## Chen lab PCB (Rev 1) modification to change power-up state of solenoids to "off"

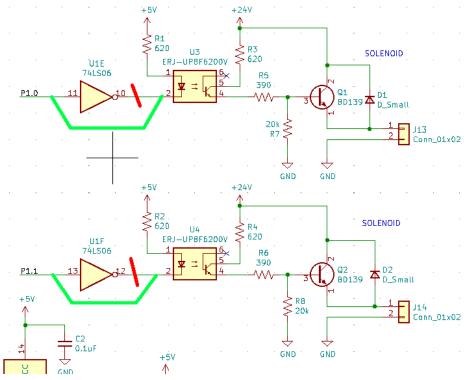
Cut traces from U1-10 and U1-12

Wire from U1-13 to U4-2 Wire from U1-11 to U3-2
